**ADDENDUM #7**

**36521-91345-T06**

**Laporte and Leonard WWPS Reliability Upgrade**

Date: January 13, 2022

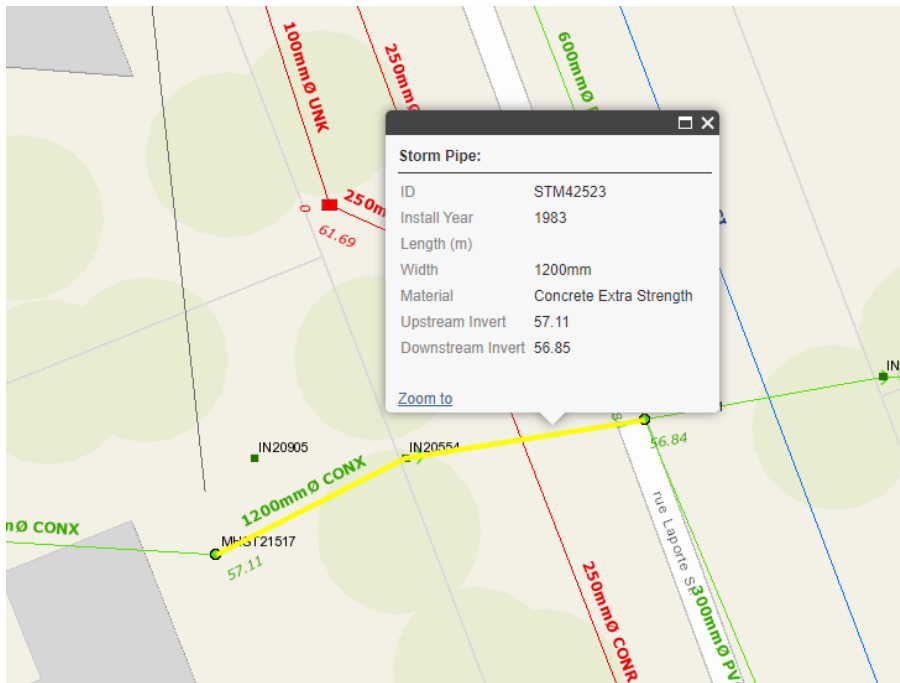
Q1. Please provide the invert level of MHSA42278

A1. MHSA42278 information:

N.INV.61.82m  
 S.INV. 61.81m  
 W.INV. 61.80m
